94 Series, 95 Series, and 97 Series Relay Sockets

Obsolescence of old socket part numbers.

Product Change Notification

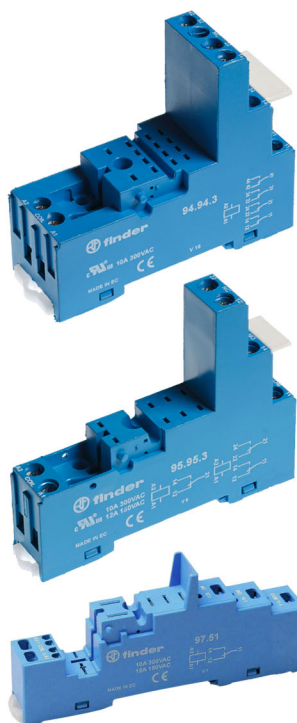
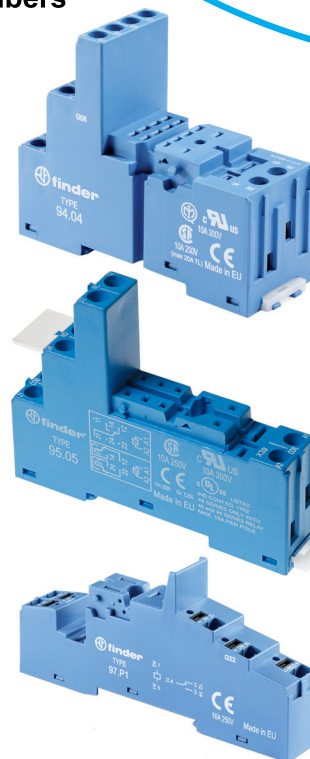
Over the years, with advancement of new designs, improved characteristics and production, Finder is obsoleting a few older sockets. The already established new versions will replace the old versions with no change to wiring configurations.

94.92.3
94.92.30
94.94.3
94.94.30
95.55
95.55.3
95.93.3
95.93.30
95.95.3
95.95.30
97.51 / 97.51.3
97.51.7
97.52 / 97.52.3

94.02
94.02.0
94.04
94.04.0
95.P5
95.P5
95.03
95.03.0
95.05
95.05.0
97.P1
97.P1.7
97.P2

No change to electrical and wiring configuration.

Note: If using suppression module 99.80 it is necessary to update to newer version 99.02 for the 94 and 95 Series numbers.
